Office Action Summary	Application No. 10/816,697	Applicant(s) BOURGEOIS ET AL.	
	Examiner Tony Chuo	Art Unit 1795

DETAILED ACTION

6. Claims 19-24, 26, and 30-35 are rejected under 35 U.S.C. 102(b) as being anticipated by Donelson et al (US 6492053).

**FIG 1**

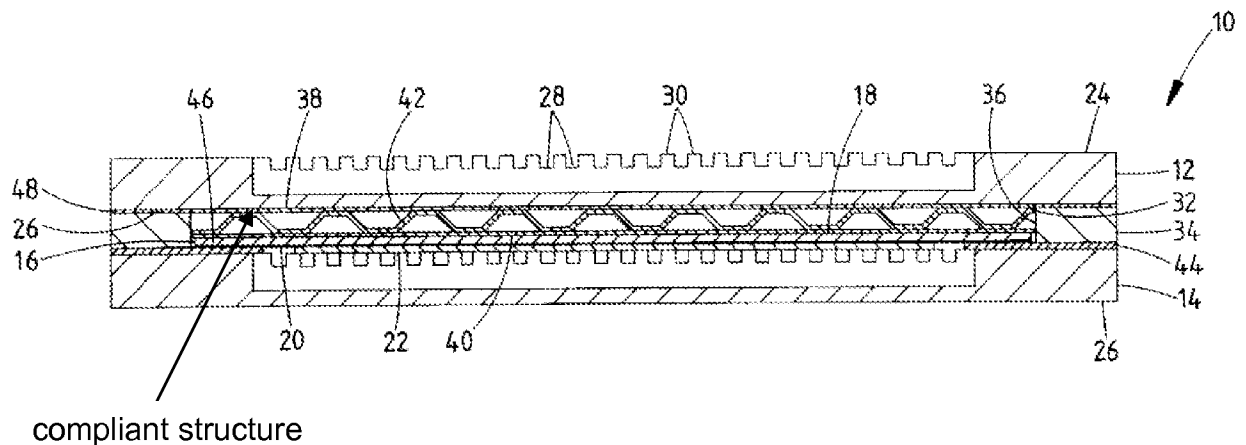
Regarding claim 19, the Donelson reference discloses a fuel cell stack comprising: a plurality of planar fuel cell “16” that inherently comprises a first fuel cell assembly and a second fuel cell assembly electrically coupled together such that sealed manifolds extend between the first and second fuel cell assemblies, each fuel cell assembly comprising: a hollow manifold comprising a top wall “34” & “42” and a bottom wall “14”, wherein the hollow manifold includes a fuel gas inlet manifold “54” (sealed fuel passage) and a fuel gas outlet manifold “56” (sealed fuel passage) for allowing fuel to enter and exit the hollow manifold; and a fuel cell “16” comprising an anode “18”, a cathode “22”, and an electrolyte “20” disposed there between, wherein a portion of the top wall “34” of the top wall forms a side wall in direct contact with the fuel cell such that the fuel cell is coplanar with the hollow manifold and wherein a portion of the top wall “42” extending between the fuel cell and the sealed fuel passage forms a compliant structure that is capable of accommodating thermal expansion of the fuel cell in the same plane as the hollow manifold (See Figures 1 and 2 and column 5, line 45 to column 59).

Regarding claim 20, it also discloses a cathode flow channel “28” coupled to the hollow manifold of the first fuel cell assembly and the second fuel cell assembly that is configured for directing an oxidant between the first fuel cell assembly and the second fuel cell assembly (See Figure 1, and column 8, lines 9-10).

Regarding claim 34, it also discloses a compliant structure "42" that is located adjacent to the fuel cell and the sealed passage (See Figure 1).

Regarding claim 35, it also discloses a compliant structure "42" that comprises a corrugated structure (See Figure 1).
